MIL-E-1/1300A(EL)
AMENDMENT-1
31 January 1969

MILITARY SPECIFICATION SHEET

ELECTRON TUBE, RECEIVING
TYPE 7246

This Amendment forms a part of Military Specification Sheet MIL-E-1/1300A(EL), 27 July 1967.

Figure 1: Superregenerative Operation test circuit

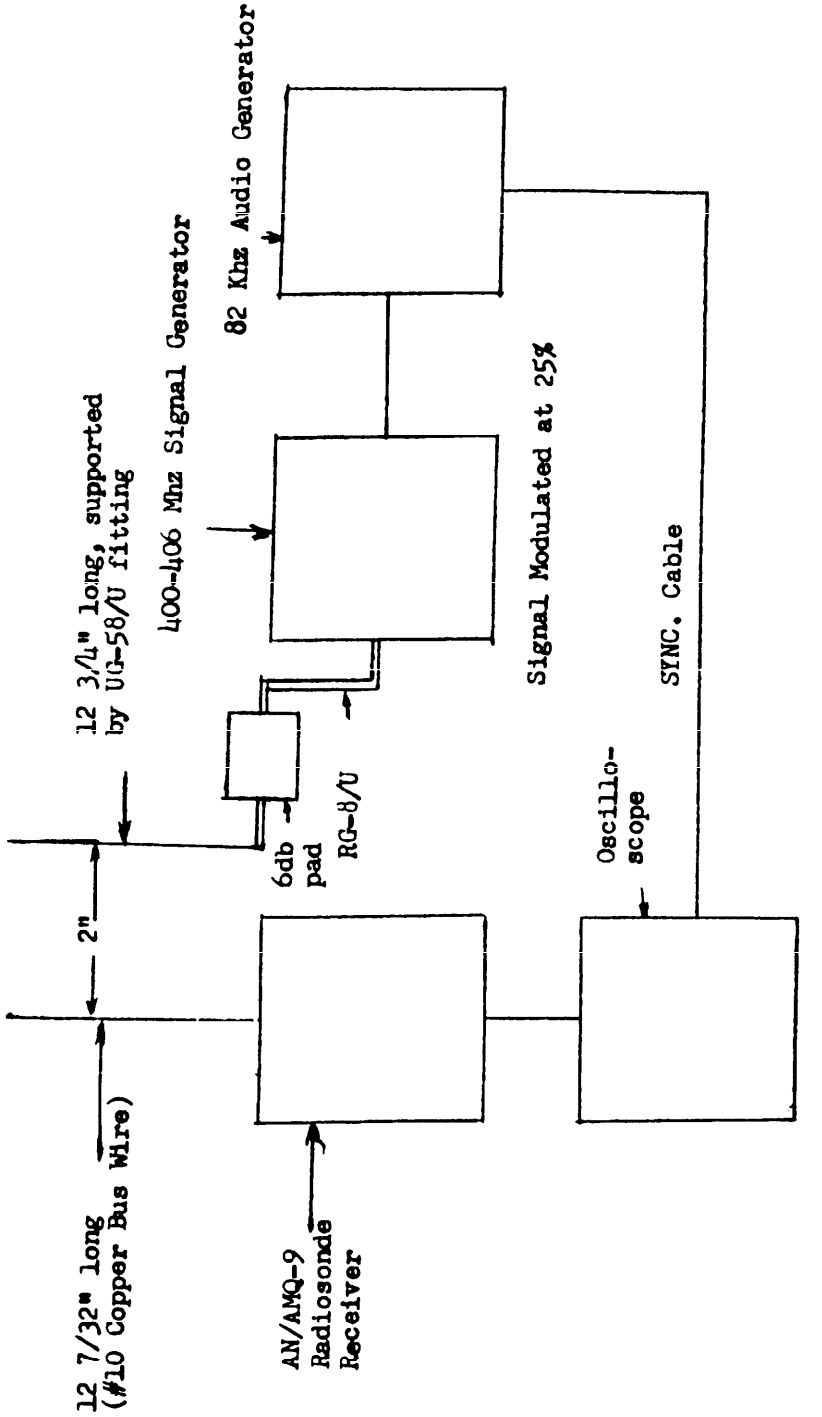
Page 8, Figure 1: Replace with new Figure 1, attached.

Page 6, Note 9, a, b, c, d: Replace with the following:

"Super-regenerative Operation shall be tested in a Radiosonde AN/AMQ-9 (unit approved by Contracting Officer, or, during Qualification Tests: unit approved by the qualifying activity) detector circuit modified as follows, and in accordance with the block diagram depicted in Figure 1 herein:

a. The r-f signal generator output shall be 200 uV.

b. The antennas should be isolated from surroundings as much as possible."
